Western States Petroleum Association  
Credible Solutions • Responsive Service • Since 1907

March 22, 2017

Re: WSPA Comments on ARB February 7, 2017 2<sup>nd</sup> Refinery Co-Processing Working Session

Figure 7. Process level energy inputs, outputs and CO<sub>2</sub> emissions for illustrating process unit level energy and CO<sub>2</sub> allocation

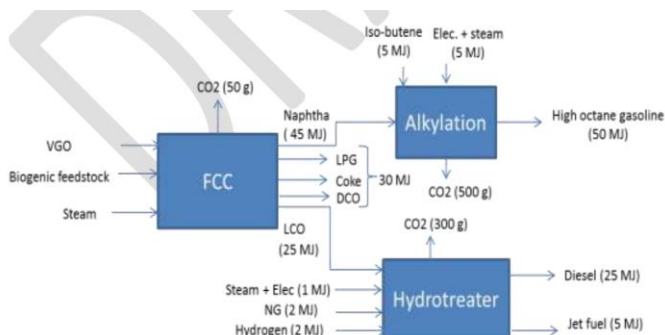
It is also suggested that ARB use more realistic refining process schematics when developing illustrations and examples in support of the various allocation methods. For example, Figure 7 of Discussion Paper shows the FCC naphtha intermediate being routed to an alkylation unit to produce high octane gasoline which is not the case. This schematic is further discussed in a subsequent comment. A useful reference regarding process schematics is “*Petroleum Refining: Technology and Economics*”<sup>2</sup>.

WSPA believes that the treatment of Alkylation in co-processing models needs to represent actual refinery operations. Alkylation is mentioned in several instances in the Discussion Paper. As shown in Figure 7 (below), the Discussion Paper presents a potentially confusing schematic (as noted in a previous comment) where one could assume that the naphtha from the effluent of the FCC unit is injected into an alkylation unit and reacts with petroleum-based isobutene to form alkylates (high octane gasoline blend stocks). The LPG stream from the FCC unit is treated as a finished product and sold as a NG substitute for its energy content.

In reality, olefin feed from an FCC unit’s Unsaturated Gas Plant (butylene, propylene, amylene) is directed to the Alkylation Unit which also receives isobutene feedstock (some from the FCC but mostly imported). The C7-C9 paraffinic alkylate product is a gasoline blendstock directed to finished product blending. Since the LPG stream from the FCC effluent is typically sent to the alkylation unit and converted to premium gasoline blend stock, the assumption that it will be sold as a process fuel product is inappropriate.
